# Access Compliance Report

## Public Rights-of-Way

Intersection ID: 4480	Main Street: KEMPSFORD_DR	Cross Street: SILVER_GLEN_LN	Location: SE
ADA ID: 8E1710371C40	Ramp Type: Perpendicular Diagonal	Initial Pass/Fail: Fail	Overall Compliance: No
		Severity Score: 8.75

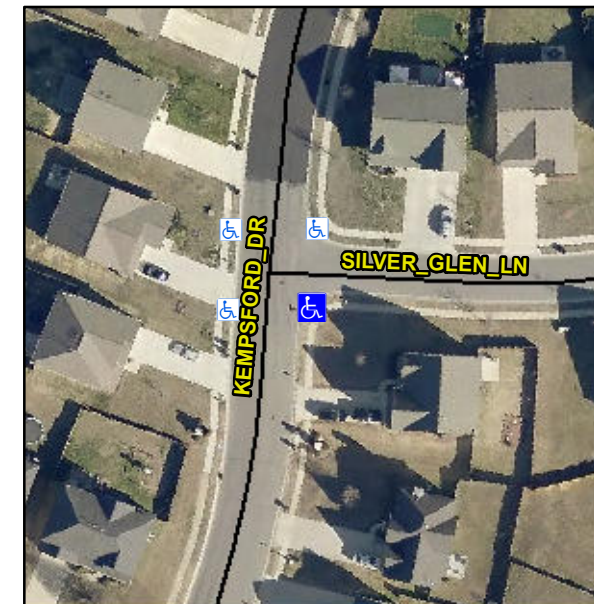
**Not Found, R304.5.1**

Compliance	Description	Data	Compliance	Description	Data
N/A	Ramp Length (in)	48.0	Yes	Ramp Slope (%)	5.0
No	Ramp Width (in)	39.0	Yes	Ramp XSlope (%)	1.0
N/A	Flare Type LT	N/A	N/A	Flare Type RT	N/A
N/A	Flare Slope LT (%)	N/A	N/A	Flare Slope RT (%)	N/A
N/A	Flare Traversable LT?	N/A	N/A	Flare Traversable RT?	N/A
N/A	Landing Length (in)	N/A	N/A	DWS Provided?	N/A
N/A	Landing Width (in)	N/A	N/A	DWS Contrast?	N/A
N/A	Landing Slope (%)	N/A	N/A	DWS Length (in)	N/A
N/A	Landing X Slope (%)	N/A	N/A	DWS Full Width?	N/A
N/A	Landing Curb? (Y/N)	N/A	N/A	DWS Offset (in)	N/A
N/A	Shared Landing?	N/A			
N/A	Gutter Ponding?	N/A	N/A	Gutter Slope (%)	N/A
N/A	Gutter Lip Ht (in)	1.0	N/A	Gutter X Slope (%)	N/A
N/A	Painted X Walk1?	No	N/A	Painted X Walk2?	No
	X Walk 1 Direction	To N		X Walk 2 Direction	To W
N/A	X Walk 1 Width (in)	N/A	N/A	X Walk 2 Width (in)	N/A
	X Walk 1 Slope (%)	1.3		X Walk 2 Slope (%)	2.9
	X Walk 1 X Slope (%)	2.5		X Walk 2 X Slope (%)	1.8

**Remove & Replace Curb Ramp With Two New Directional Ramps or Equivalent.**
